Errata to TFP501, Datasheet Literature Number SLDS127B

Sheet 22, change the package figure as described:

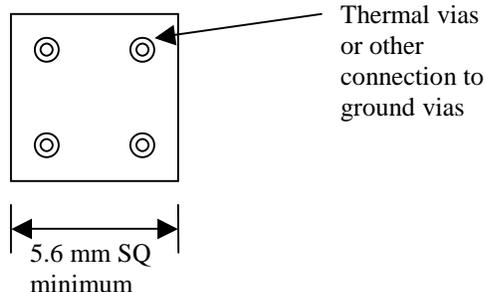
ISSUE

The size of the exposed metal on the PowerPad package figure is shown as larger than on production devices. When providing a thermal land, it may be smaller than assumed from the package drawing. If routing traces under the power pad, some method of protection from shorts between the traces or vias and the PowerPad should be used.

- Re-size the thermal pad dashed box from its present size to 5.05mm, centered in the package.
- Note the dimensions and change note D:

Add dimensions to re-sized pad showing: $\frac{5.05}{3.95}$ SQ

Change note D to read:

The package thermal performance may be enhanced by bonding the thermal pad to an external thermal plane. This pad is centered on the package and is electrically and thermally connected to the backside of the die.
